ADDENDUM #2

**INVITATION TO BID
for
ADMINISTRATION BUILDING
ROOF REPLACEMENT**

Bid # 2016-13R

Utah County Administration Building
Roof Replacement, Bid # 2016-13R

1/D101

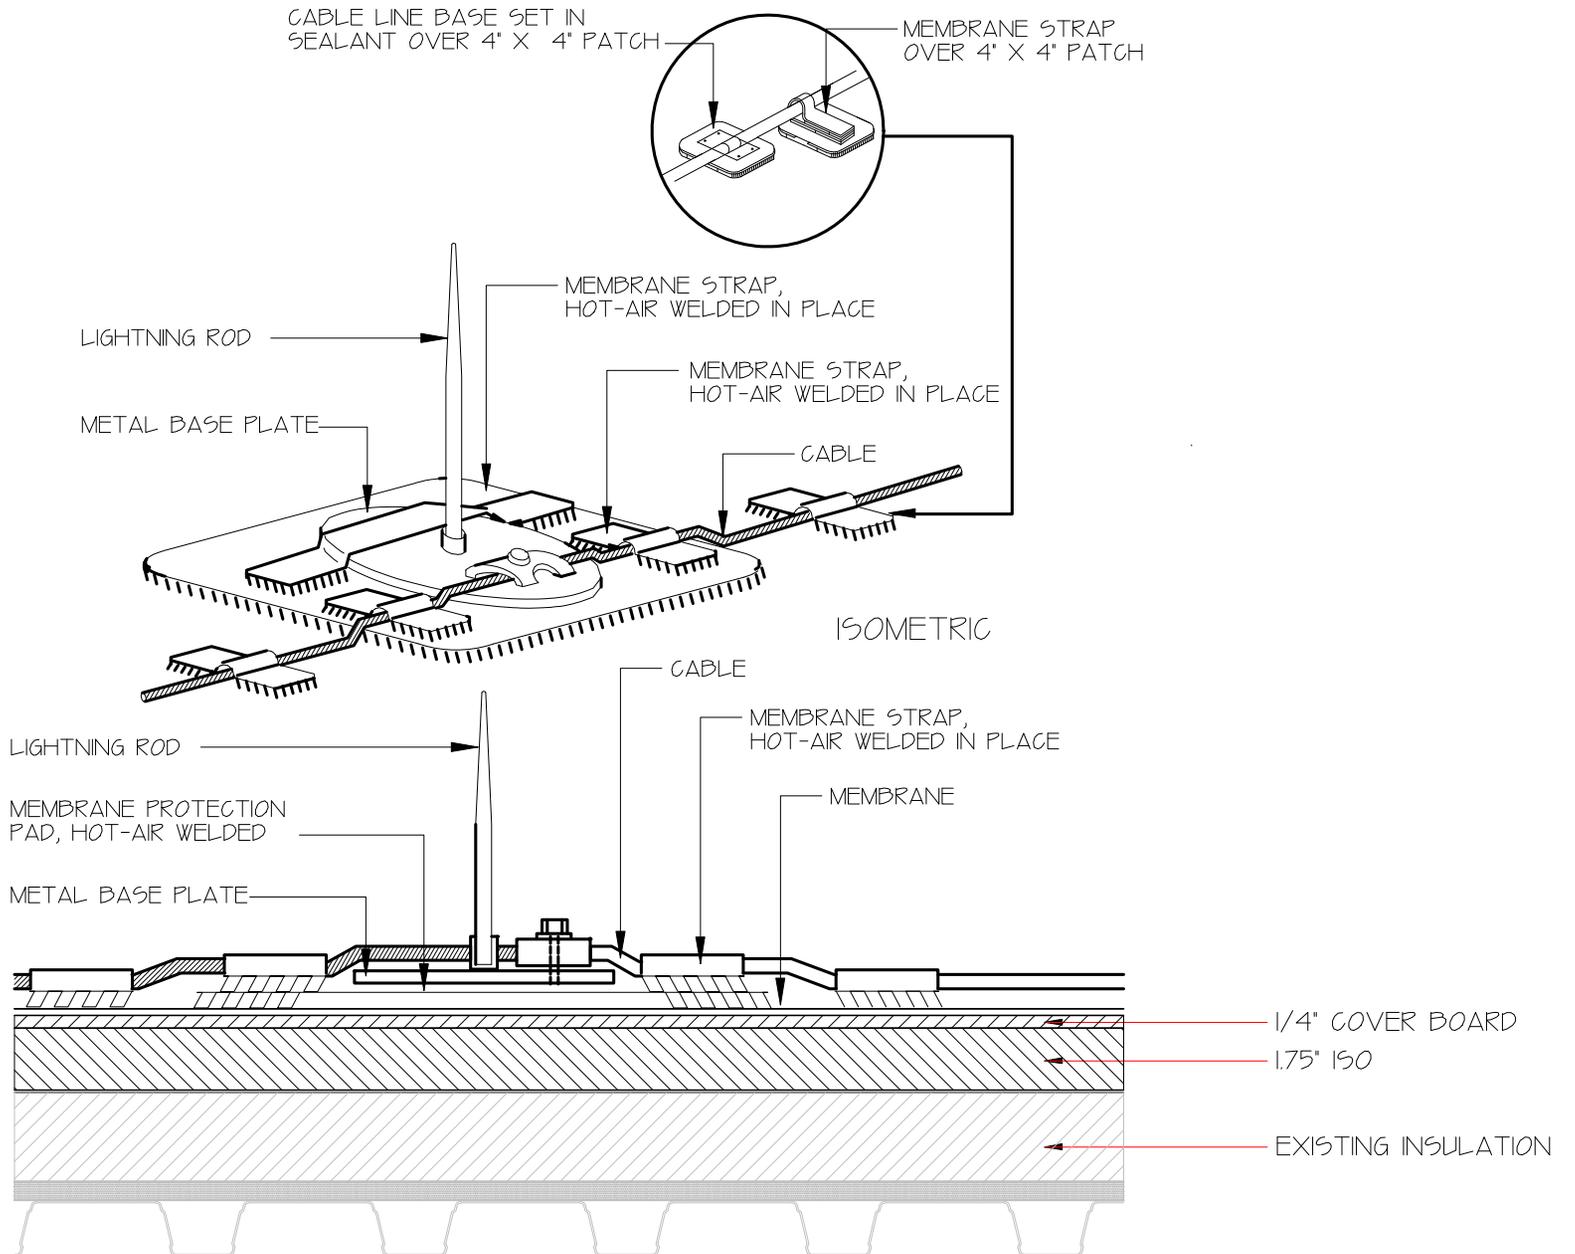
Drawing D101:

Details 1/D101 and 9/D101 shall be replaced by the attached details.

1. Contractor shall complete this project on or before November 11, 2016.
2. Contractor shall reinstall lightening protection per details 1/D101 and 9/D101. Re-certification is not in this scope.
3. Change 01 1000 1.9 A. On-site work hours: to read "Monday – Saturday 6:00 AM – 8:00 PM and in compliance with Provo City Noise Ordinance."
4. Add 07 5419 2.1 4. Johns Manville Denver, CO. JM PVC ES approved manufacturer.
5. Change 07 5419 1.1 C.1.a to read "Mechanically attached:"

← WIDTH OF WALL VARIES →
 12" MOST EXTERIOR WALLS
 28.5" AT CONNECTOR ROOFS

- COATED METAL DRIP EDGE
- FASTENERS @ 6" OC STAGGED
- WELDED MEMBRANE FLASHING
- BONDING ADHESIVE

WELD MEMBRANE STRAP
 OVER 3" X 3" PATCH @
 2' O.C. TO SUPPORT LIGHTENING CABLES

NEW CONTINUOUS
 GALVANIZED METAL CLEAT
 FASTENED AT 6" O.C.
 STAGGERED

EXISTING WALL - HEIGHT VARIES
 CONTRACTOR REQUIRED TO ADD
 SUPPLEMENTAL ATTACHMENT ON
 HIGH WALLS PER MFG REQ.

- ADHERED MEMBRANE FLASHING
- BONDING ADHESIVE
- TERMINATION BAR
- HEAT WELDED LAP
- MEMBRANE

- 1/4" COVER BOARD
- 1.75" ISO
- EXISTING INSULATION
